DEVELOPMENT FACILITATIVE TEAM (DFT)
HEARING OCTOBER 2, 2024
UPDATE: 06/05/2024 Application Submittal

Project Number PR-2024-010446
SI-2024-00774-SITE PLAN DFT

RE: Site Plan Amendment for new construction

APPLICANT RESPONSES TO THE STAFF COMMENTS:

Landscape Plan

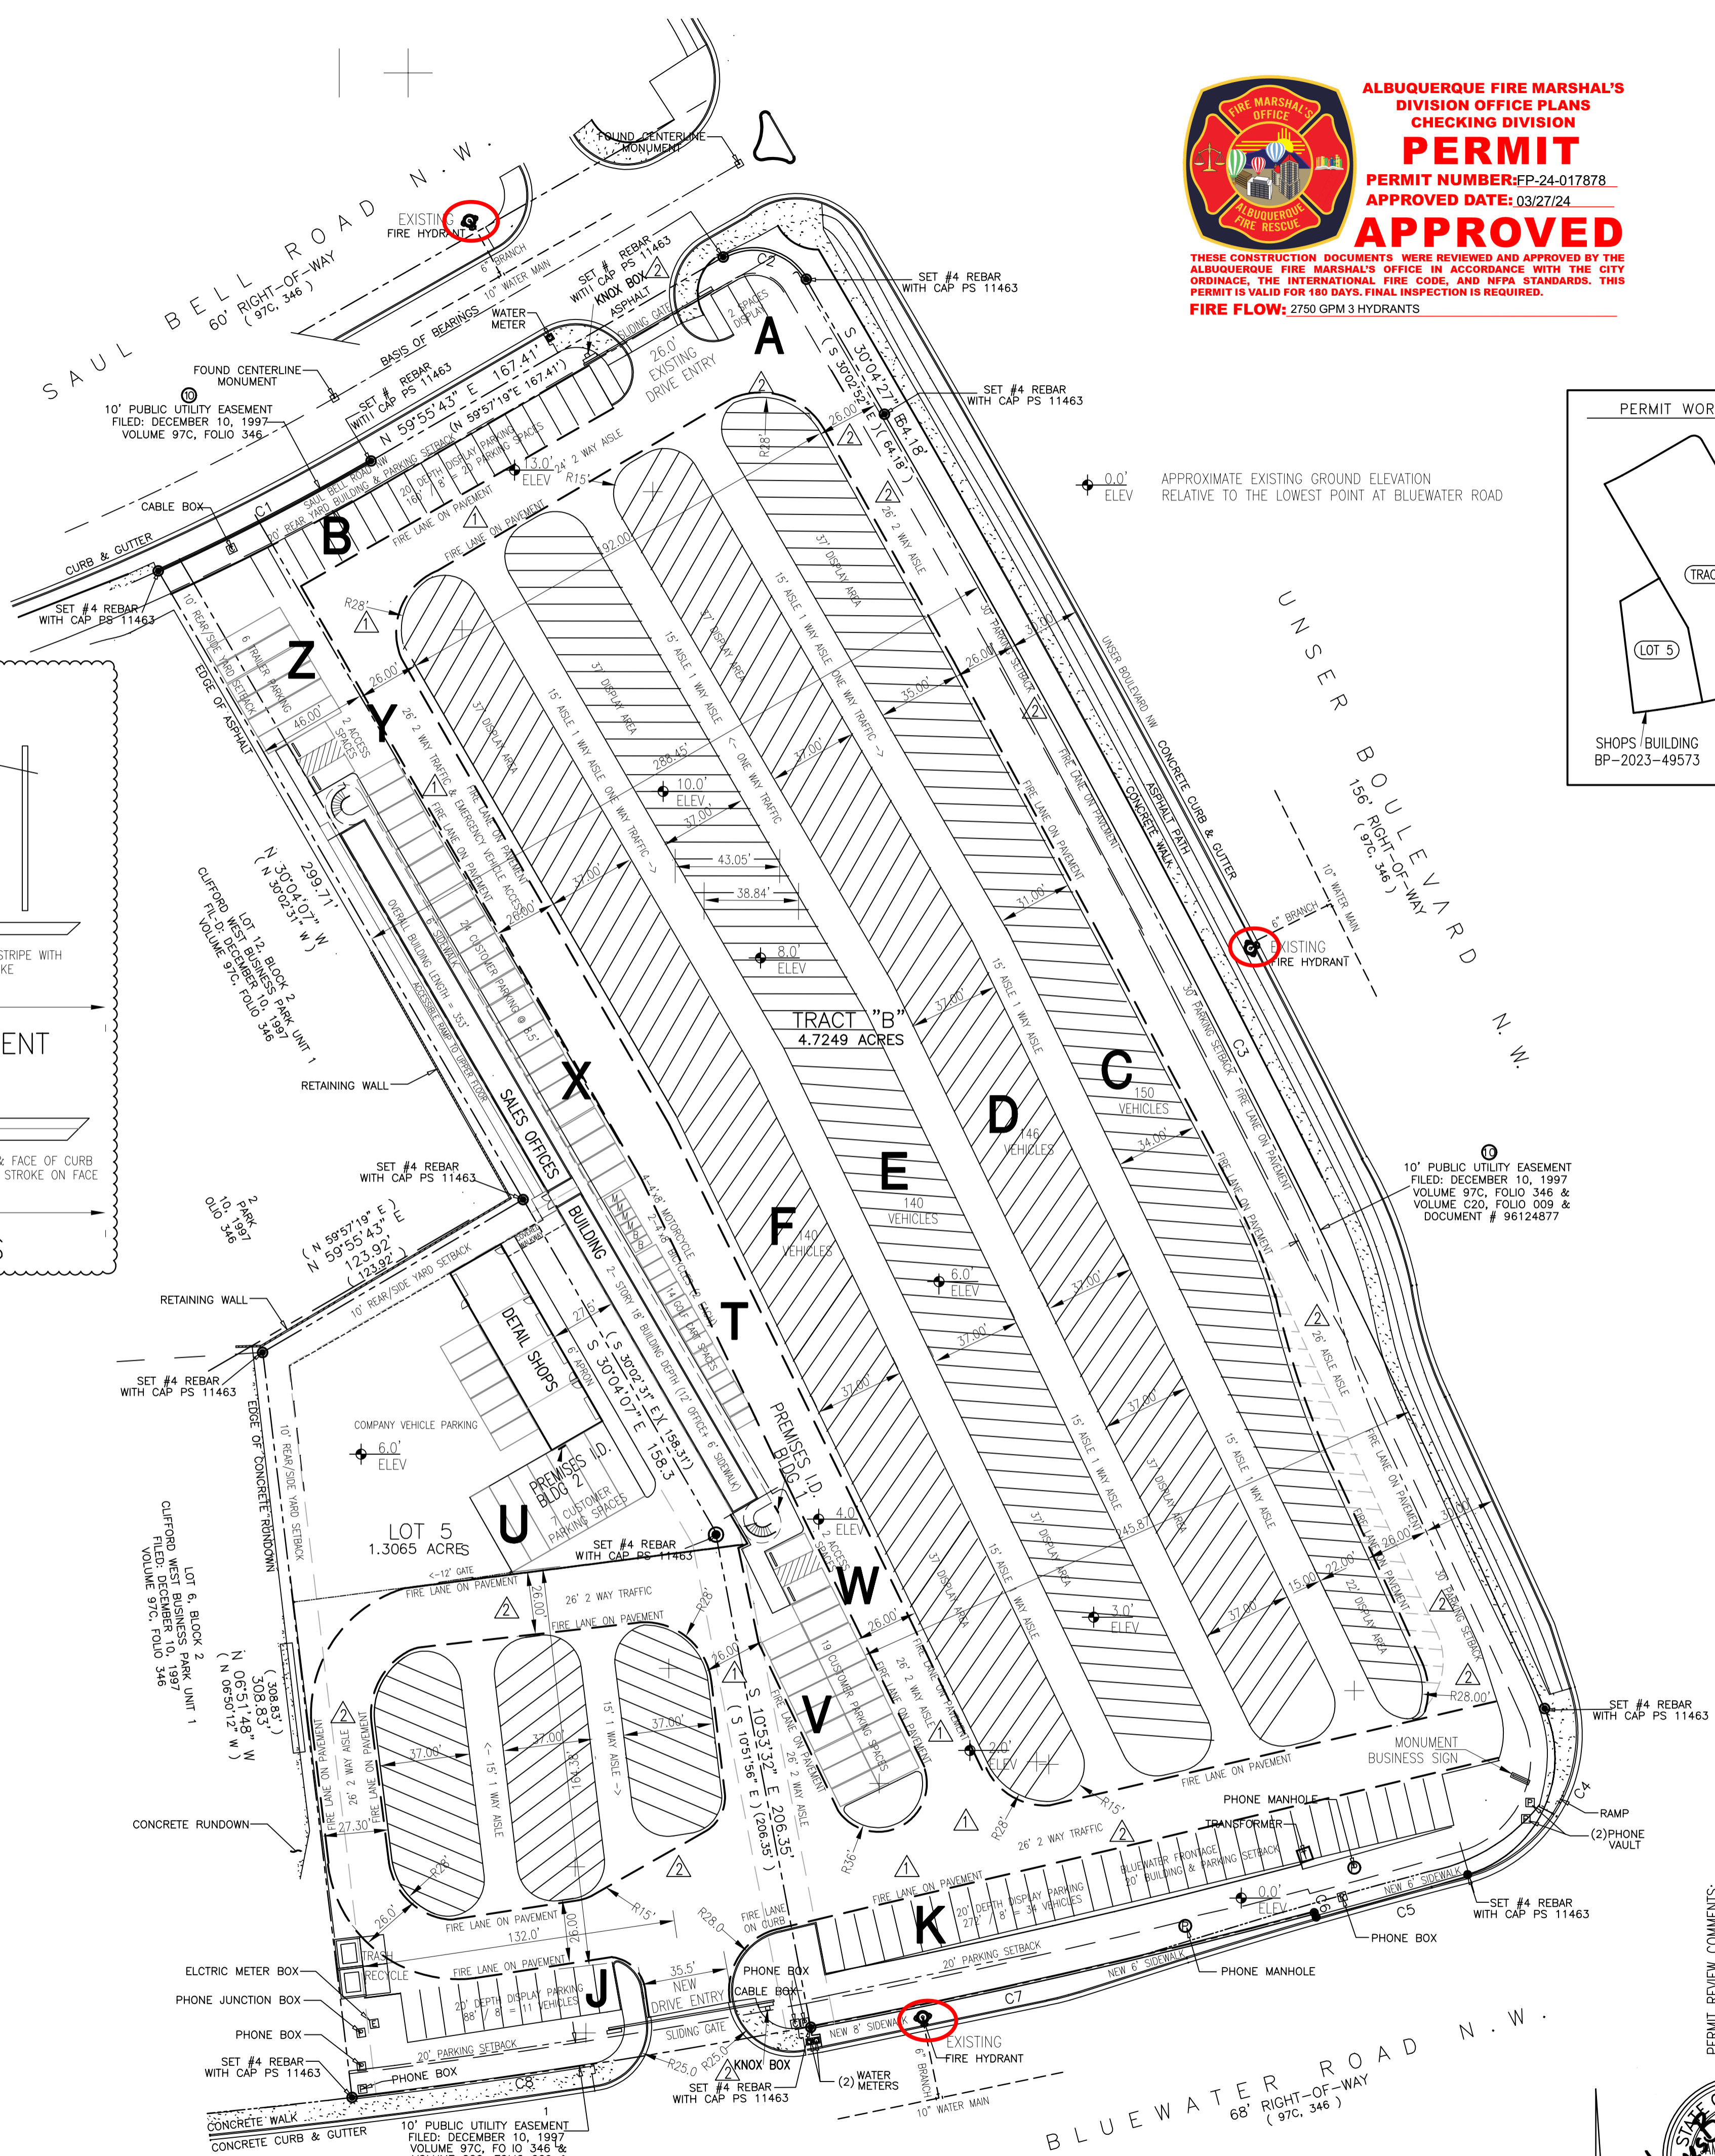
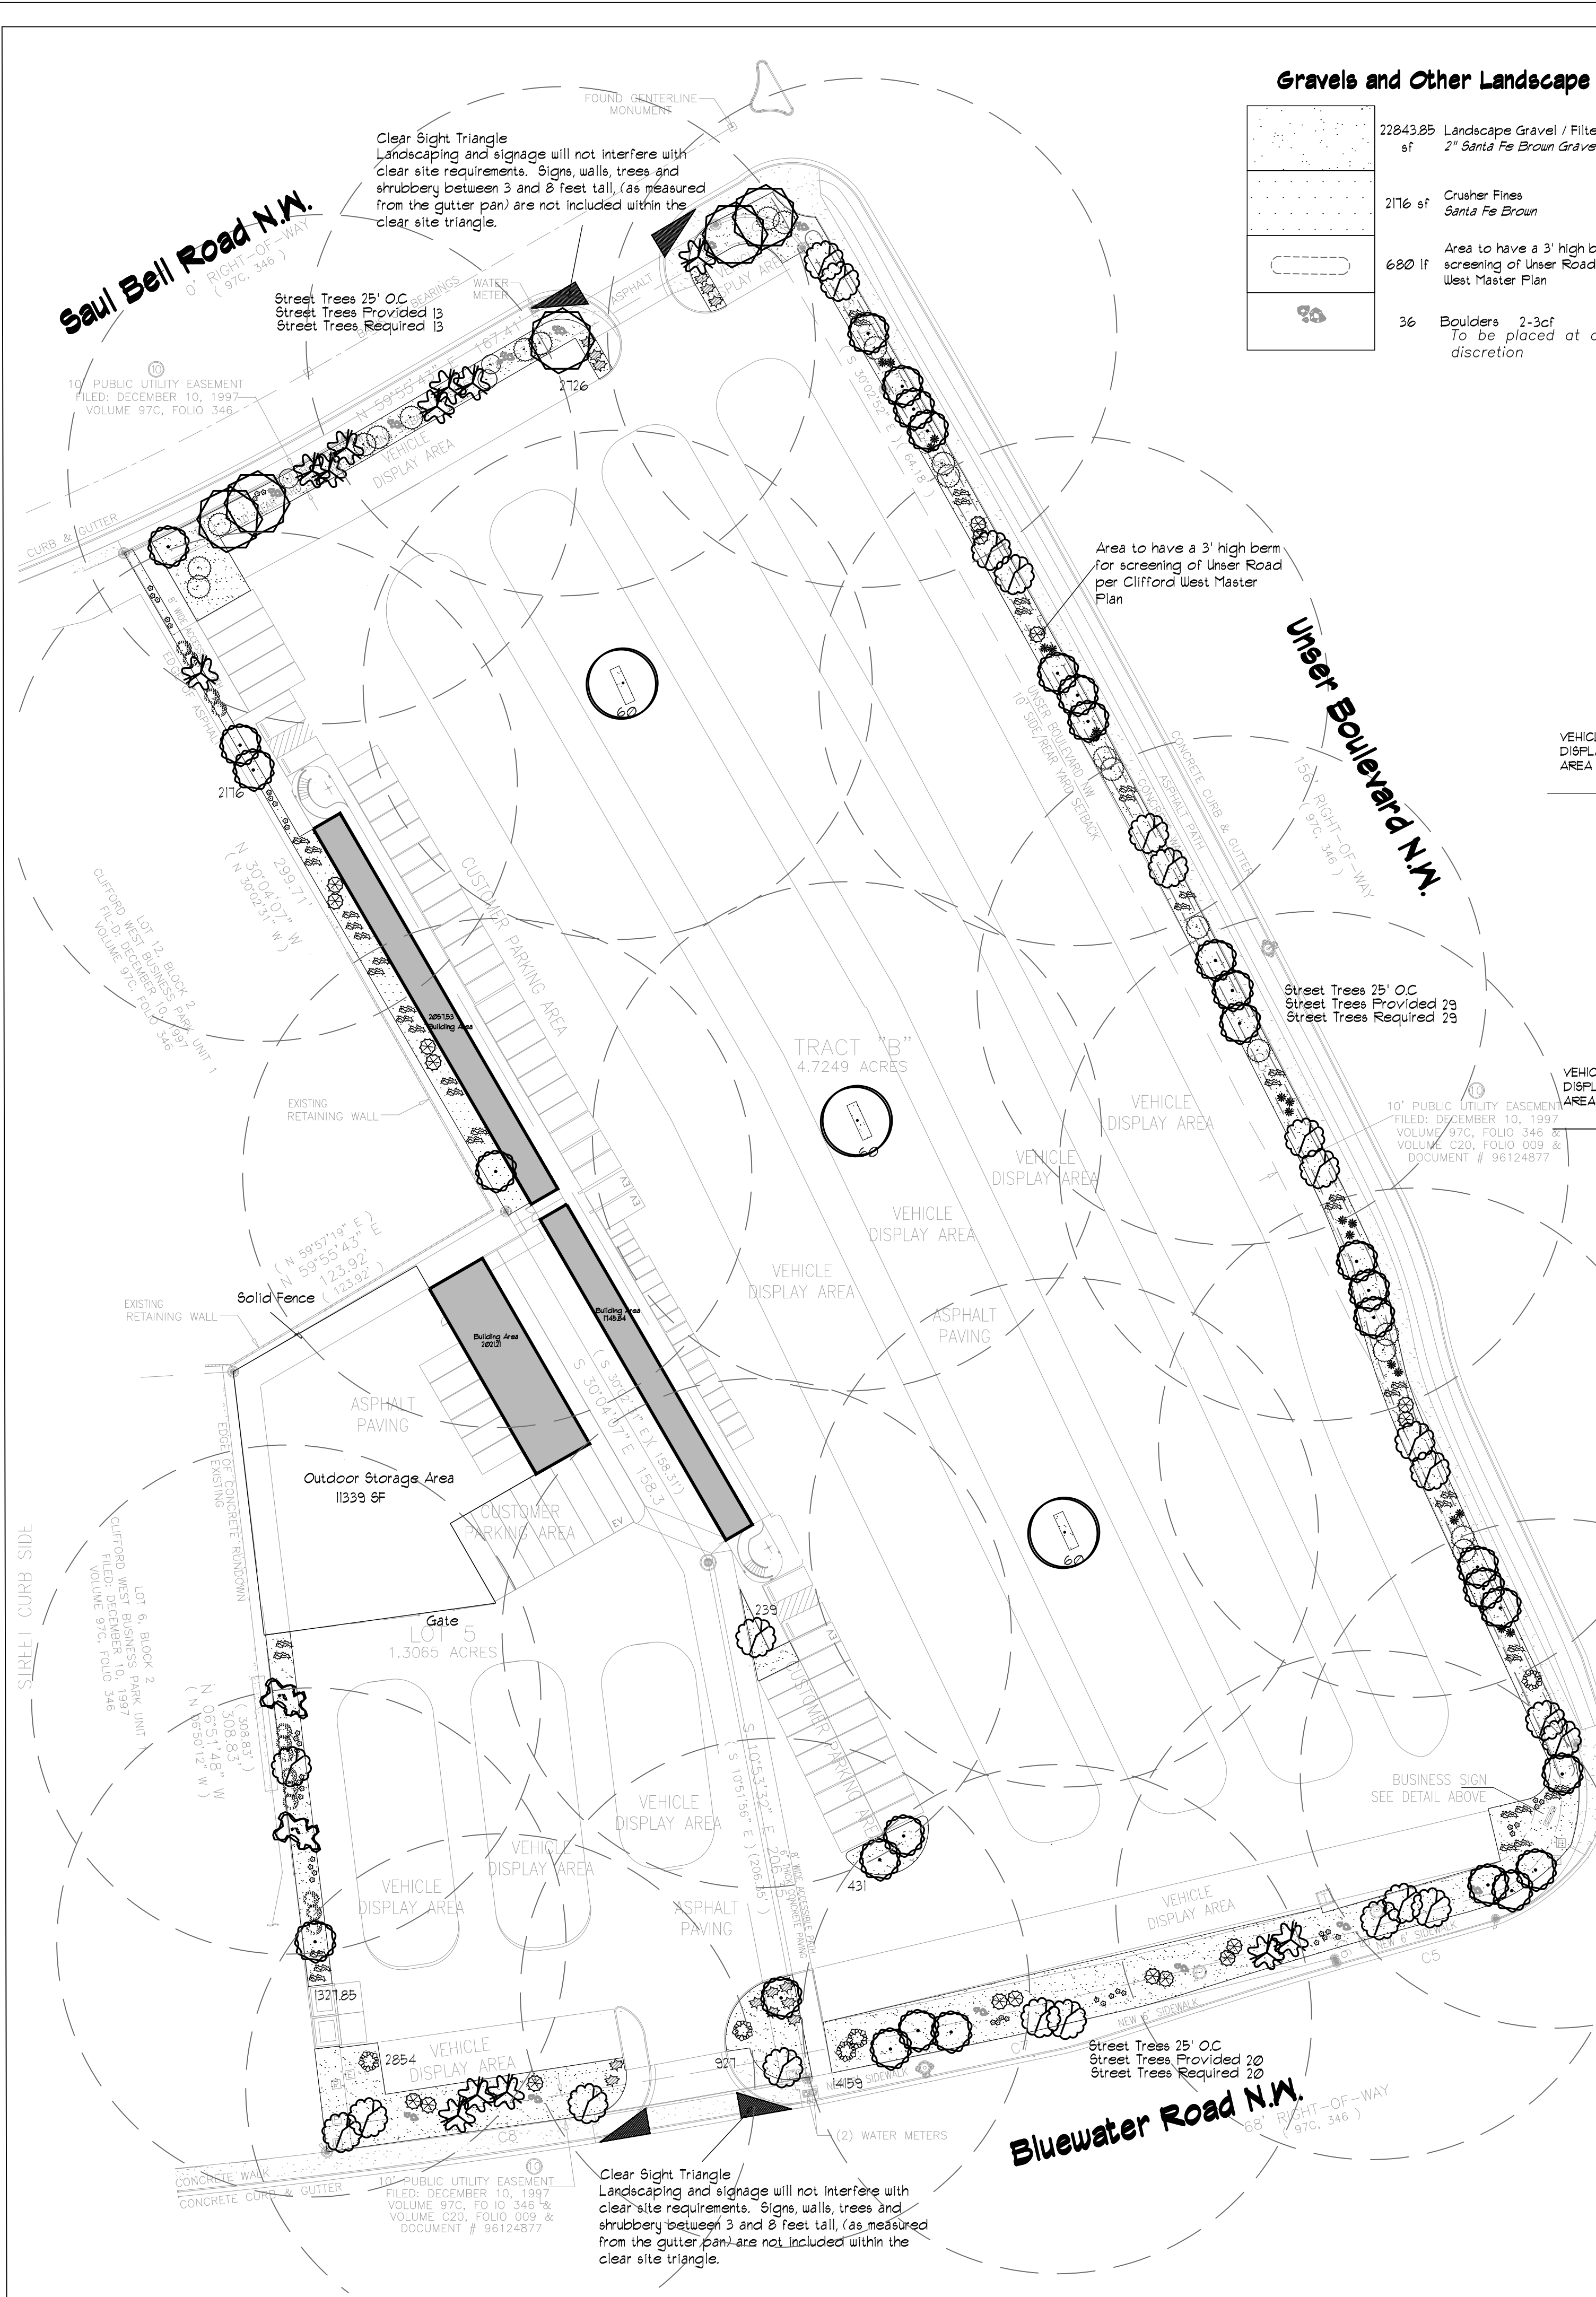
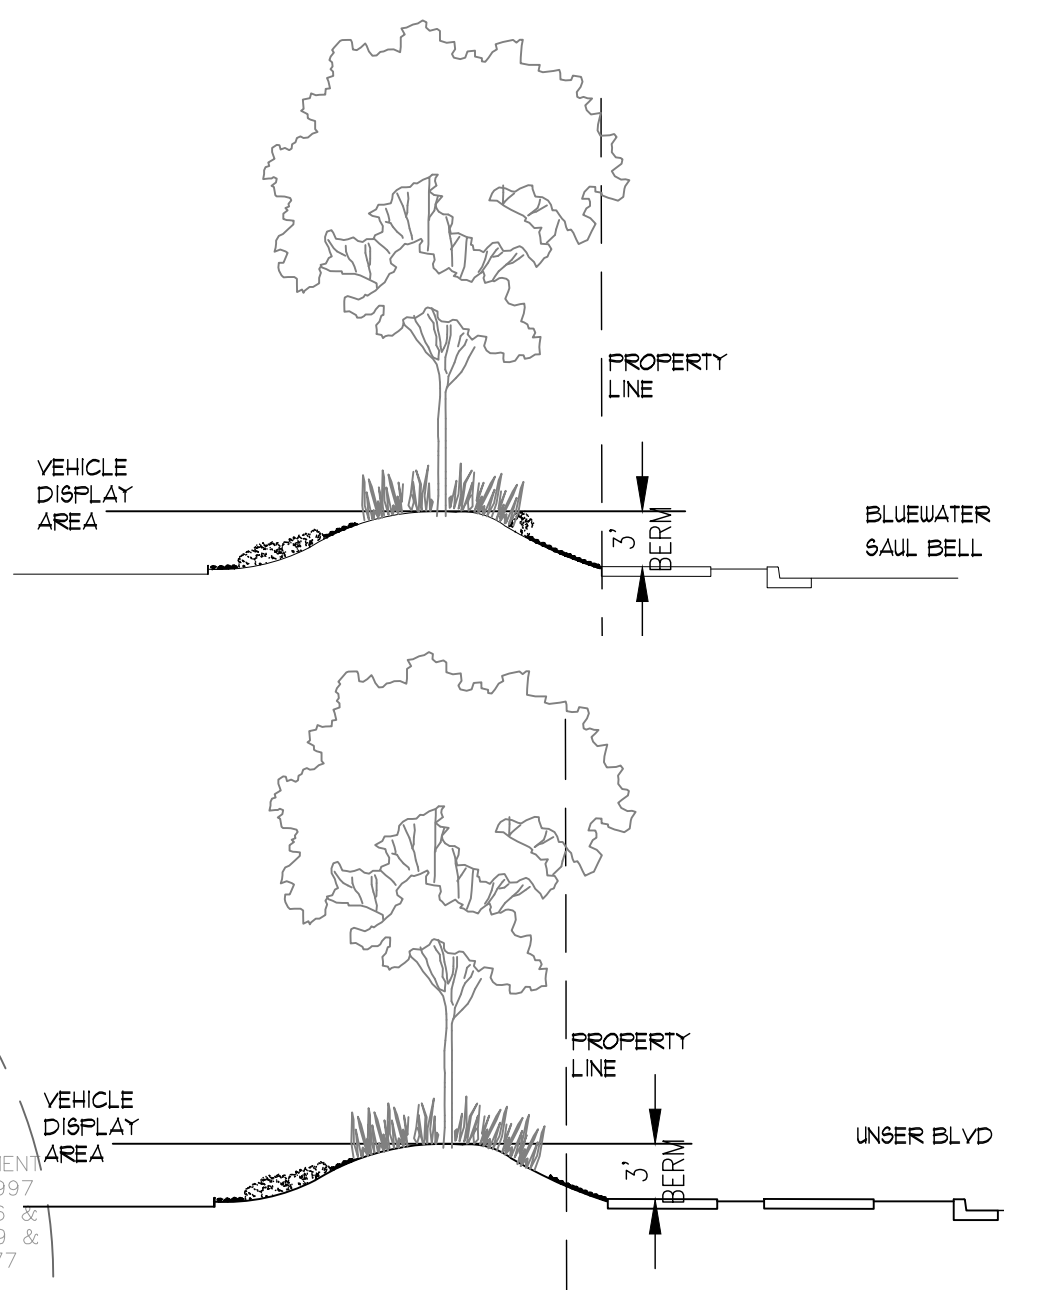
Provide relevant calculations and confirm compliance with this code. Additionally, the City of Albuquerque is in the process of eliminating non-functional turf grasses due to high water requirements compared to the function they serve. Consider proposing a different plant material for these areas.

- There is a large amount of landscaping on the landscaping plan. Clarify the landscape calculation of the net lot area. Calculations must show how the entire development meets the minimum requirement(s).

- Clarify the details for the 100 ft landscape areas and how/where berming screening areas are being used to meet the requirements of the Clifford Park plan. *See snips below referencing the plan standards.
- Per IDO section 5-6(C)(2)(a) a minimum of 15 percent of the net lot area of each development shall contain landscaping. However, the Clifford West Plan has separate requirements.

The IDO landscape coverage requirement is 15% of the Net Lot Area. The CWBP landscape coverage requirement is 18% of the Net Lot Area. The actual landscape coverage as shown on the Landscape Plan will be 20.8%.

As published in the CWBP “The front yard setback of every site and the side yard setbacks within 100 feet from the curb shall be a landscaped area. (the “Landscaped Area”). The entire front yard setback less the paved access ways and parking areas, shall be landscaped, and the side yard setbacks within 100 feet of the curb which are not used for paved access or parking areas, refuse containers loading areas, mechanical or utility equipment, or the like, shall be landscaped.” This plan provides that all front yard setback areas that are not paved shall be landscaped.

The IDO sets the front yard setback beginning at the property line while the CWMP sets it at the back of curb thus eliminating the planting area between the property line and the back of curb.

The Landscape Plan prepared for this development of Lot 5 and Tract B complies with this requirement.
